ORIGINATION FORM

Proposed Revisions to a Standard Plans Index
(Please provide all information — Incomplete forms will be returned)

Index Number: 455-101

Index Title: Square CFRP & SS Prestressed Concrete Piles -
Typical Details & Notes +

SQUARE CFRP & SS PRESTRESSED CONCRETE PILES
- TYPICAL DETAILS & NOTES

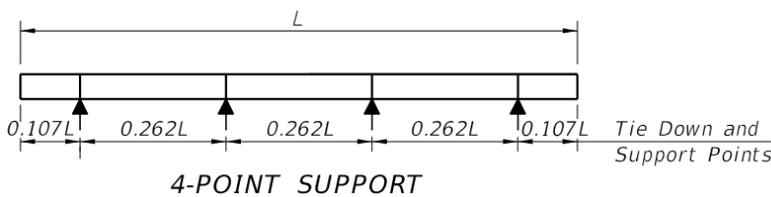
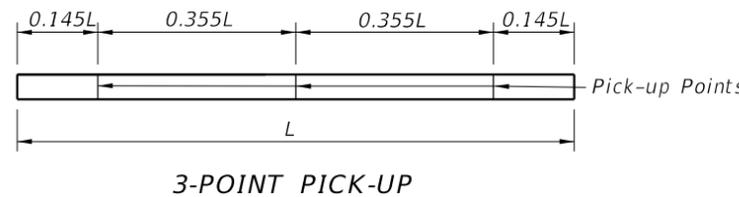
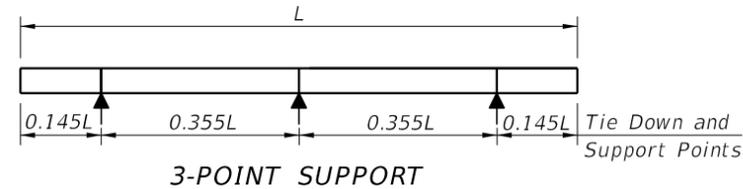
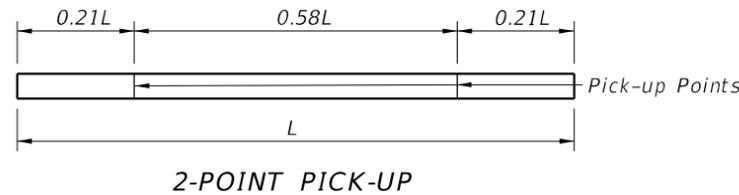
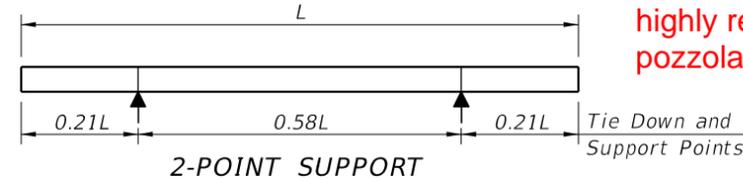
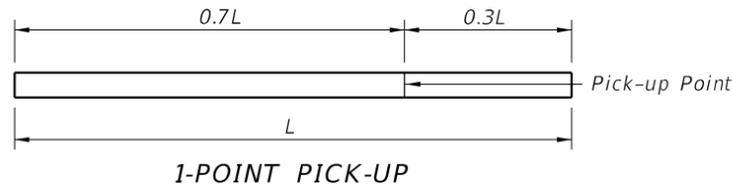
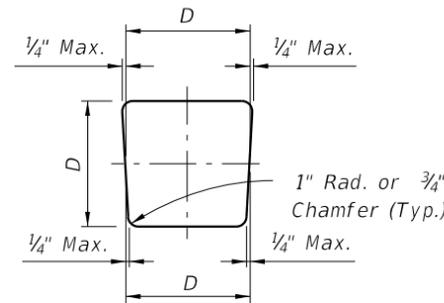
Change Silica Fume, metakaolin or ultra-fine flyash to Highly Reactive Pozzolans ; Changed Note 4B

Specification changed to fit silica fume, metakaolin and ultra-fine flyash under Highly Reactive Pozzolans. SS strand now covered by specification so only need Grade called out.

2. Concrete:
 - A. Piles: Class V (Special)
 - B. Silica Fume: See "GENERAL NOTES" in the Structures Plans for locations where the use of silica fume, metakaolin or ultra-fine flyash is required for options using stainless steel strand and reinforcing.

- b. Carbon FRP: Meet the requirements of Specification Section 932.
 - B. Prestressing Strands:
 - a. Stainless Steel: Seven-wire HSSS, ~~UNS S32205 (Type 2205) or UNS S31803~~ **Grade 240** strand, meeting the requirements of Specification Section 933.

highly reactive
pozzolans

2. Concrete:
 - A. Piles: Class V (Special)
 - B. See "GENERAL NOTES" in the Structures Plans for locations where the use of Highly Reactive Pozzolans is required for options using stainless steel strand and reinforcing.
